REAR OUTER DOOR HANDLE FAILS TO RETURN DUE TO WATER FREEZING IN THE HANDLE

Bulletin No.: 09-038/21

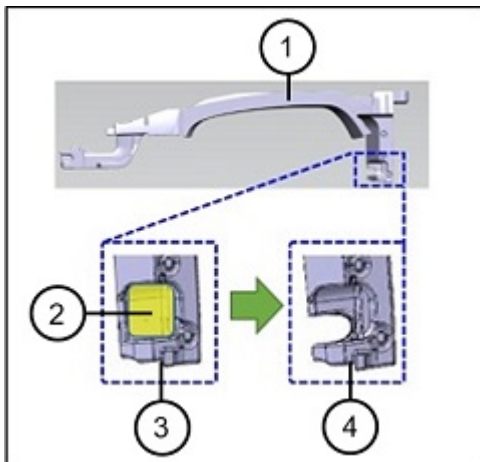
Some vehicles may exhibit the rear outer handle remains pulled out and does not return when the rear outer handle is operated in freezing temperatures. This is caused by the accumulation of snow on the rear outer handle melting and dripping water on the sliding part of the lever. When the water freezes due to decreased temperature and the handle is operated, peeled ice gets caught between the outer handle case and the slide, causing the return failure.

To eliminate this concern, the shape of the rear outer handle (1) has been changed to prevent the accumulation of water (2) on the sliding part of the lever.

(Before modification (3) and After modified (4)).

1. Verify customer concern.
2. Replace both rear outer handles with modified ones according to the instruction on MGSS.
 - Mazda3 (REAR OUTER HANDLE REMOVAL/INSTALLATION)
 - CX-30 (REAR OUTER HANDLE REMOVAL/INSTALLATION)
3. Verify repair.
